**REMARKS**

Serial No.: 10/075,596

Replacement Sheet  
U.S. Serial No. 10/075,596  
7/28/03

**FIG. 1**

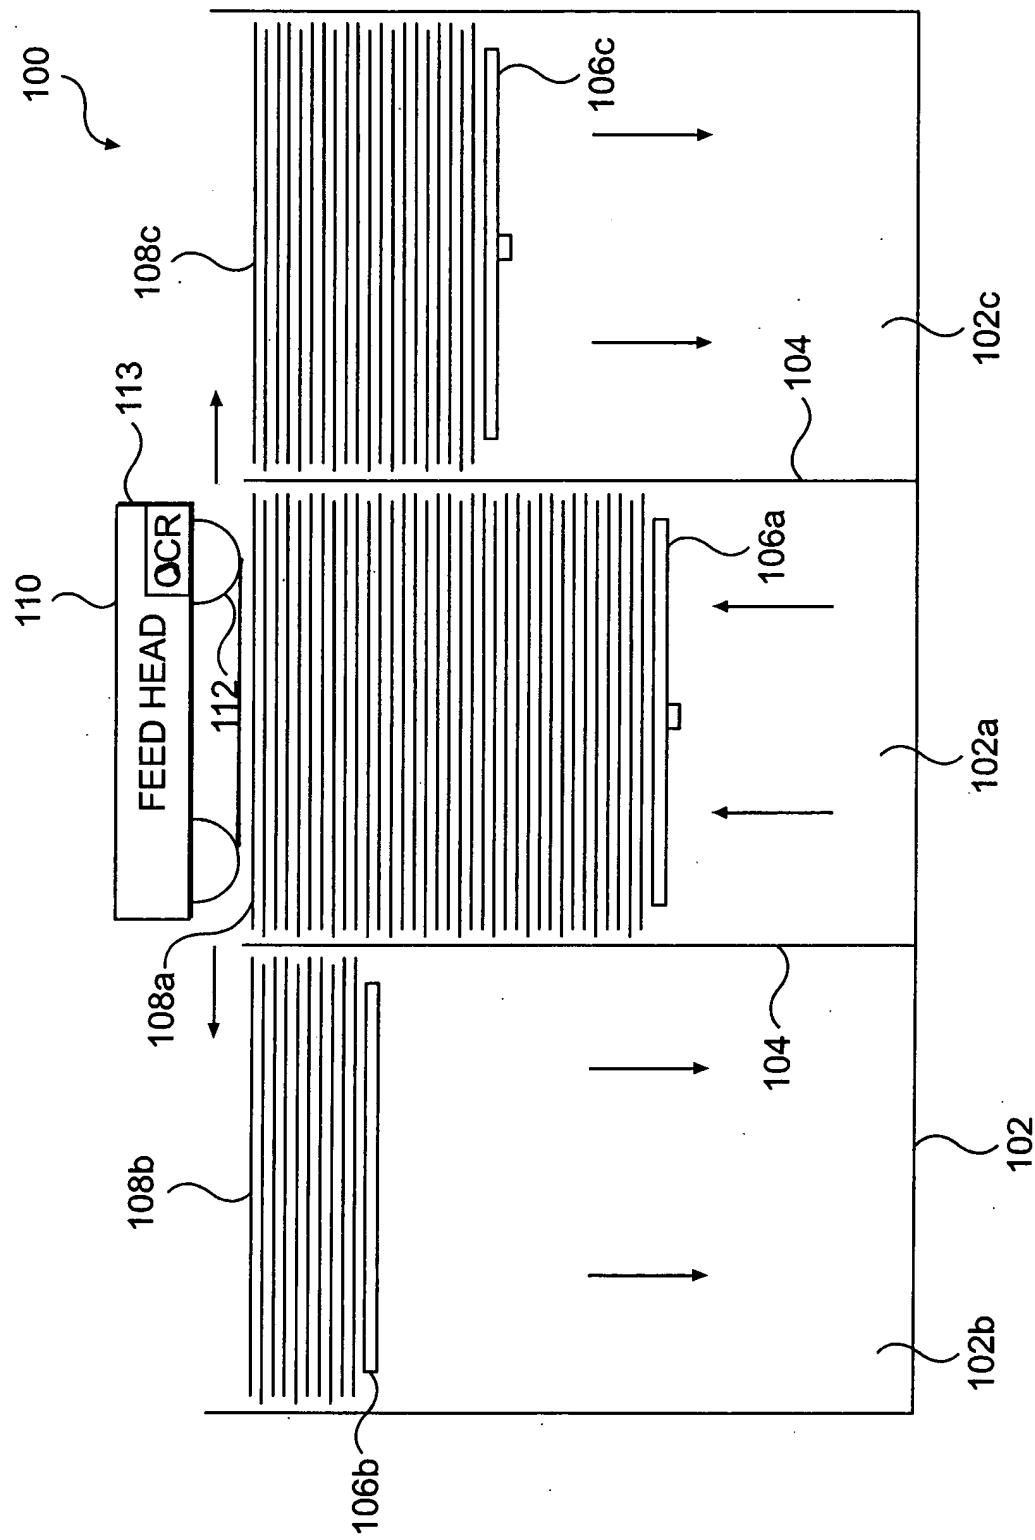
The drawings are amended to correct minor typographical and drawing errors. In figure 1, a belt 118 is shown. Also, "CCR" is changed to "OCR", as written throughout the specification. In Figures 2 and 3, "OCR" is placed in box 113. Additionally, in Figure 2, arrows are added at the end of lead lines for reference numerals 112 and 118. In Figure 4, a typographical error is corrected to "VACUUM" in box 112. Additionally, the addition of

**FIG. 4**

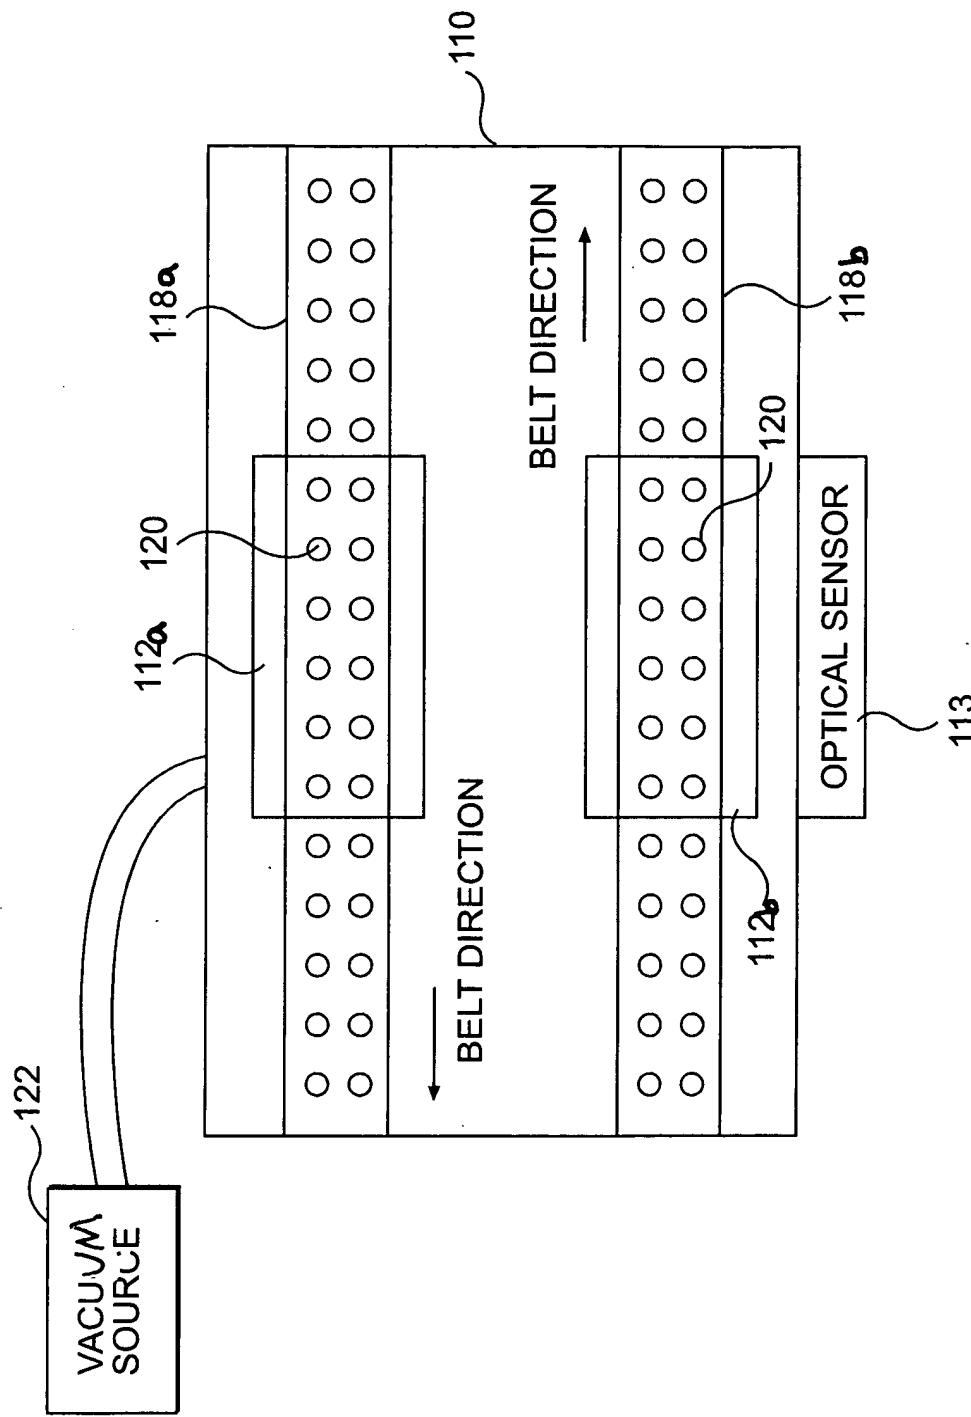
reference numerals 112a, 112b, 118a and 118b are added to Figure 4 to represent the different vacuum ports and the belts, as recommended by the Examiner.
